City of Dallas

SUBJECT **Street Design Manual Work Group Report**

Tab E
30% Plan Set Comments

Track Plan Comments

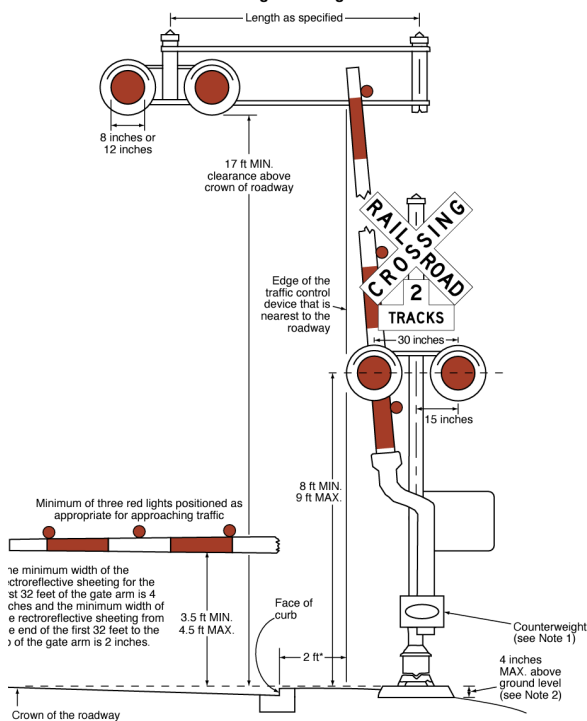
- 1) Move NB McKinney Ave inside to outside lane shift from STA 105+00 to STA 111+00. Add NB trolley-activated traffic signal to stop NB traffic to allow for trolley signal phase facilitating lane shift.

Alternative concept:

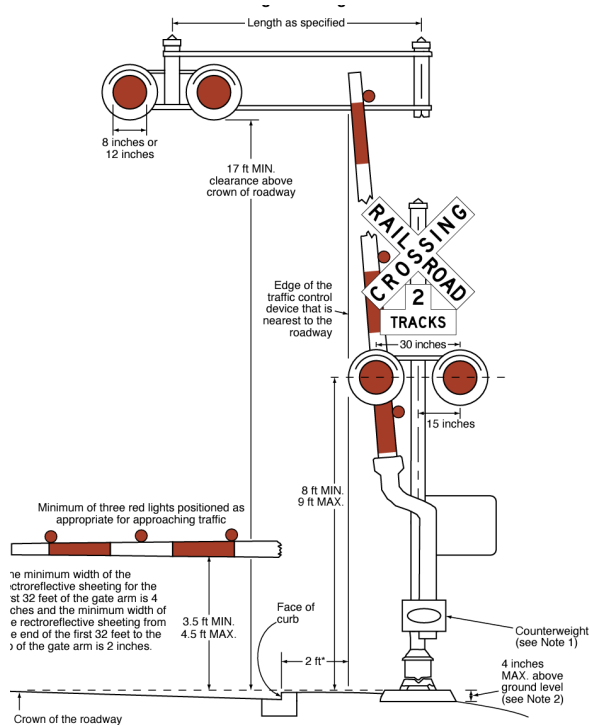
- 3) Install LED light rail transit vehicle approaching W10-7 blank out sign on new SB-facing signal mast arm at STA 110+75, to be activated along with NB McKinney red signal phase upon request by trolley operator prior to commencing inside to outside lane shift at STA 111+00:
